**PLAN COMMISSION
MEETING NOTICE AND AGENDA
Thursday, June 18, 2026
6:00 PM**

Pewaukee City Hall Common Council Chambers
W240N3065 Pewaukee Road, Pewaukee, WI

To: File
From: Magdelene J. Wagner, P.E.
Subject: Williams Residence – N27W27136 Woodland Drive
Mitigation Plan
Date: June 8, 2026

Date: May 28, 2026
To: Cold Noses Sanctuary Property LLC
From: Nick Fuchs, Planner & Community Development Director
RE: Staff Comments - Site & Building Plan Review

CERTIFIED SURVEY MAP NO. _____

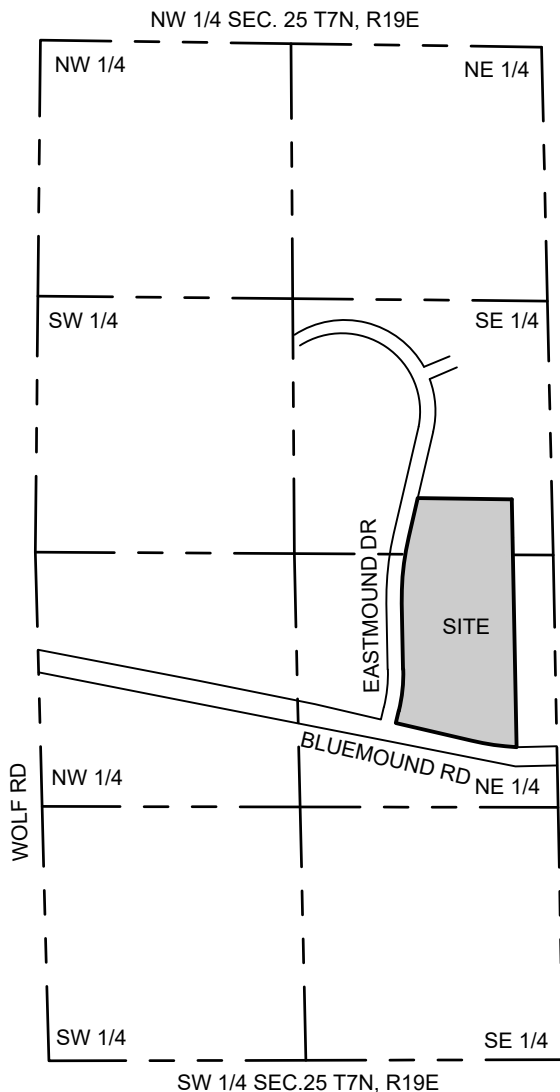
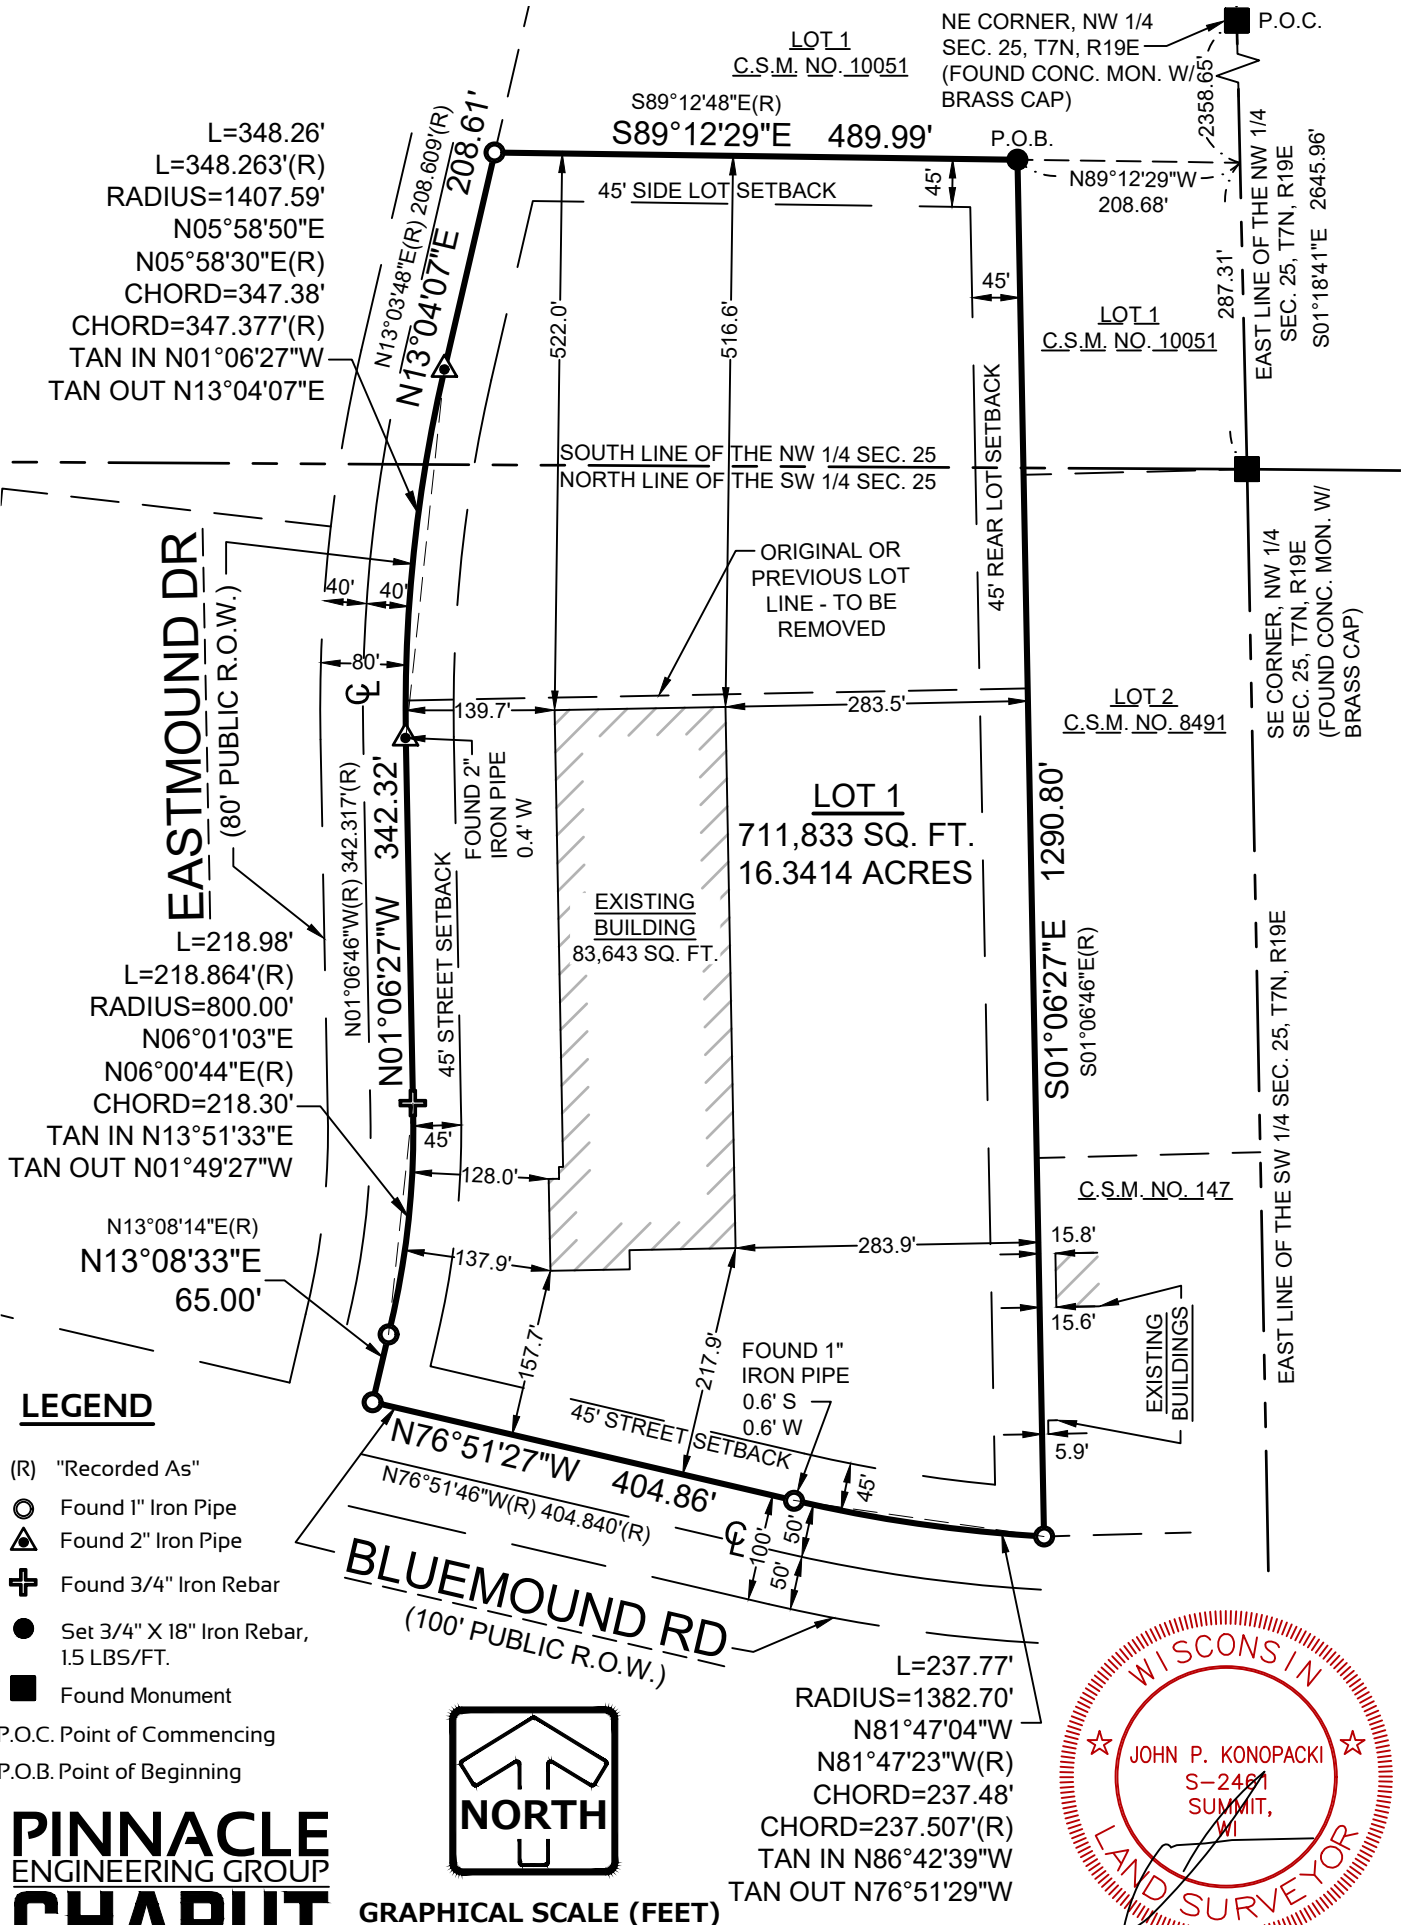
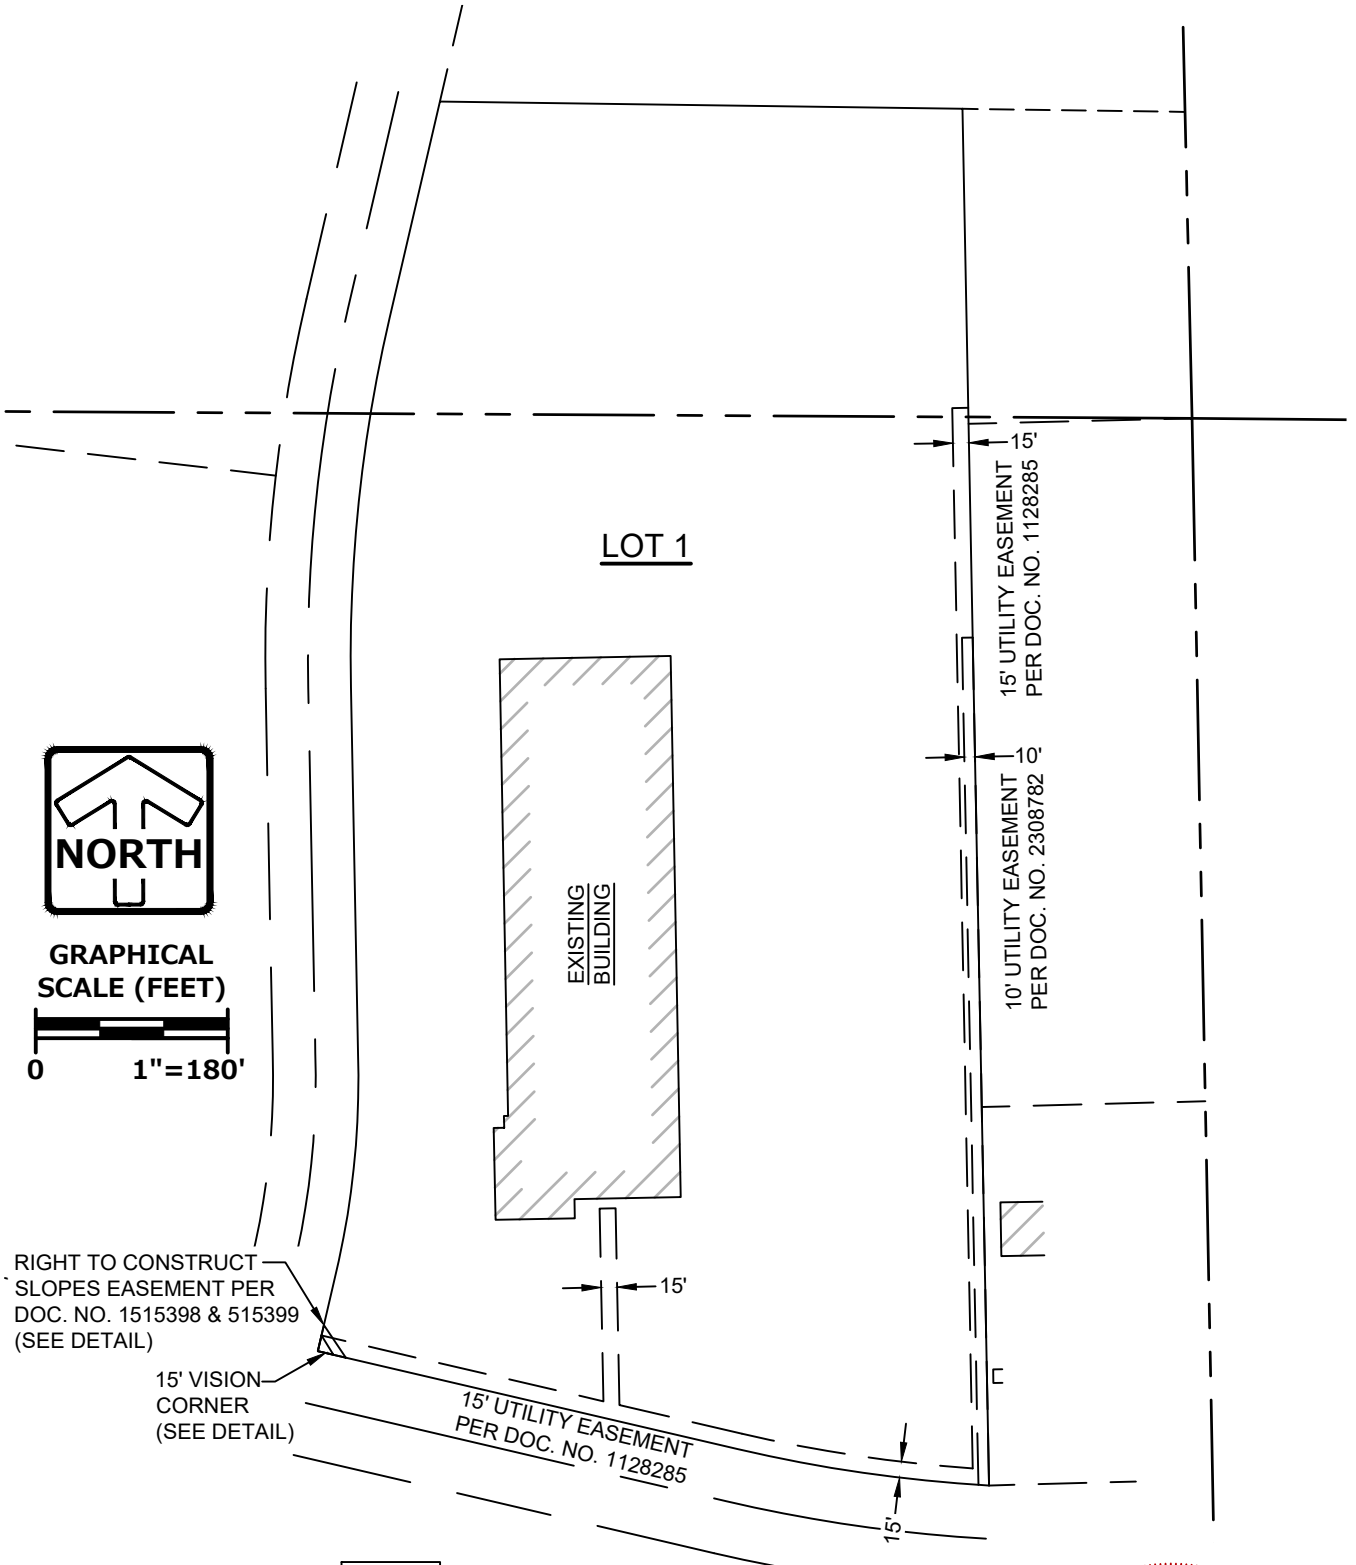
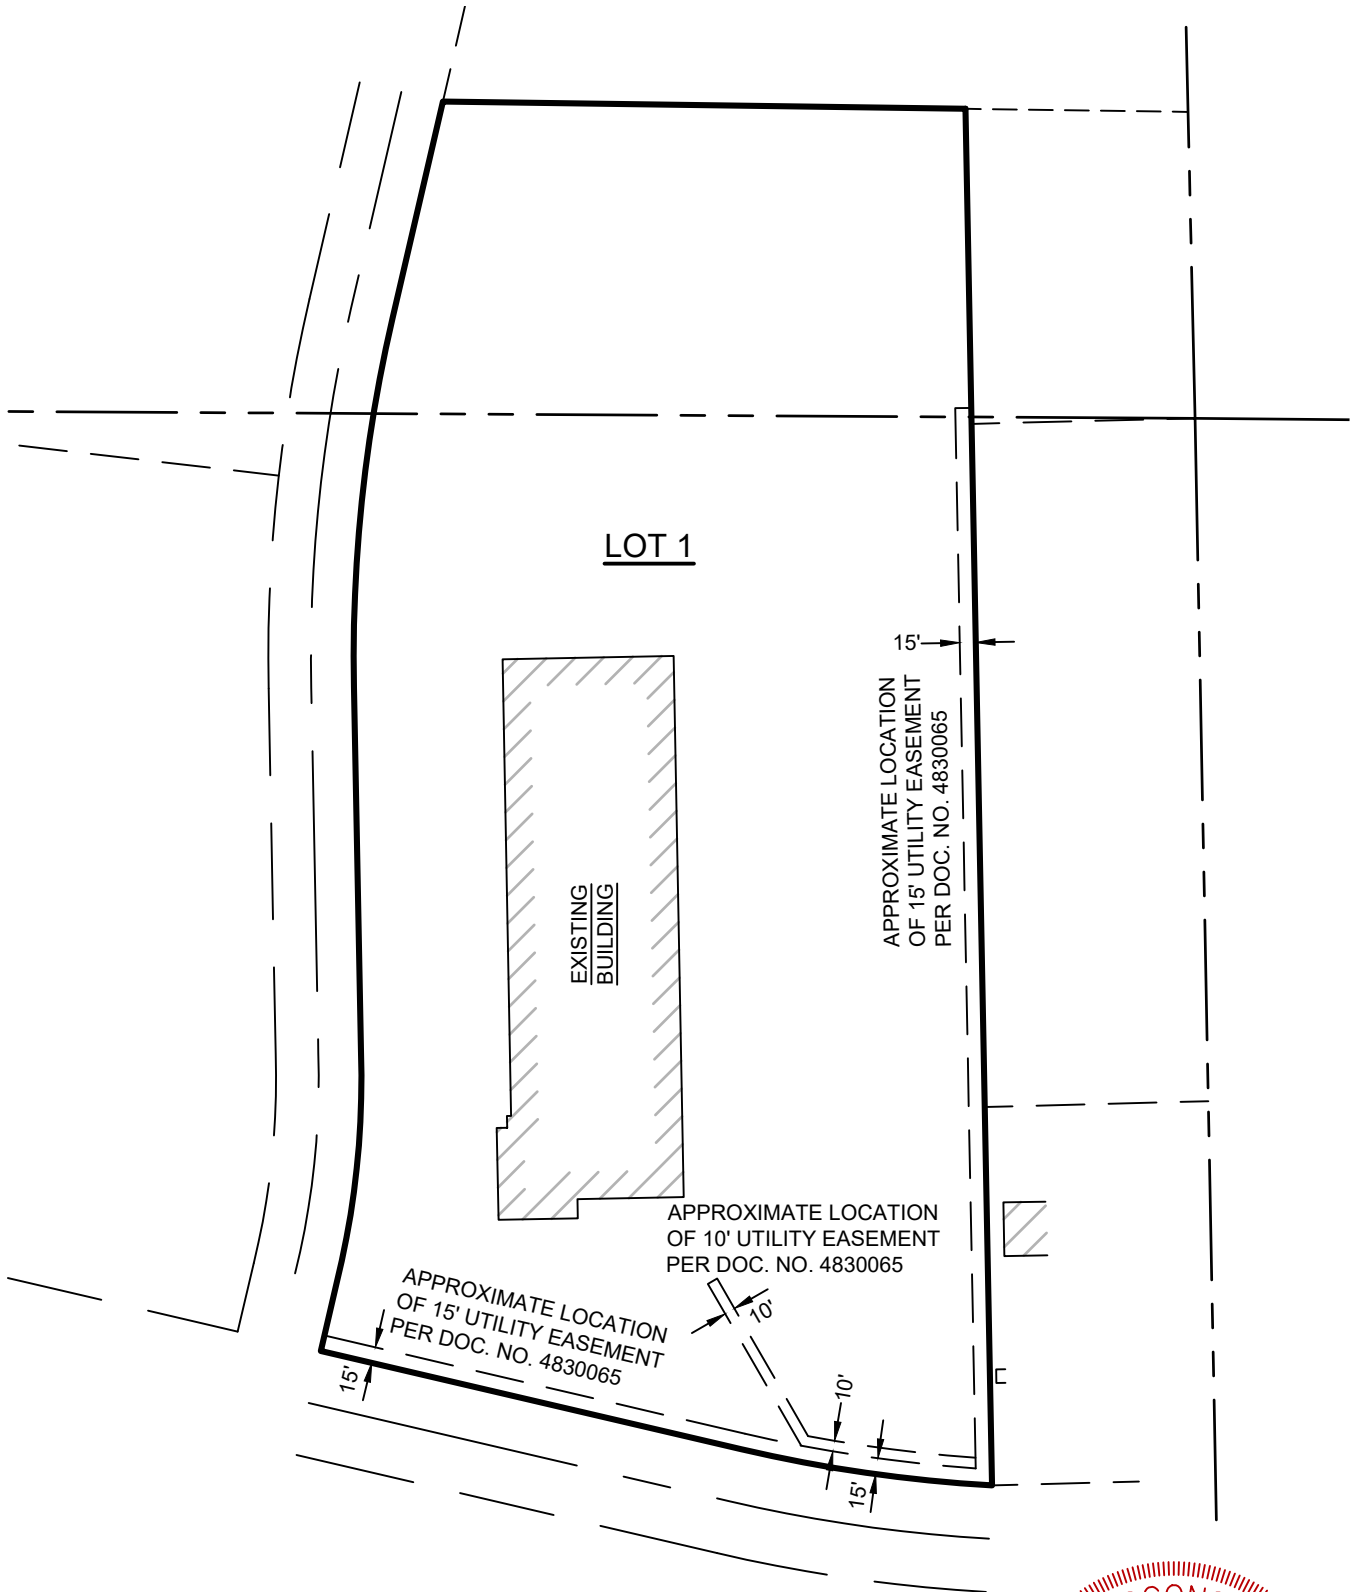
Staff recommends approval of the Certified Survey Map to combine the properties located at N4W22610 Bluemound Road, identified by Tax Key Nos. PWC 0963999016 and PWC 0963999037, into a single parcel.
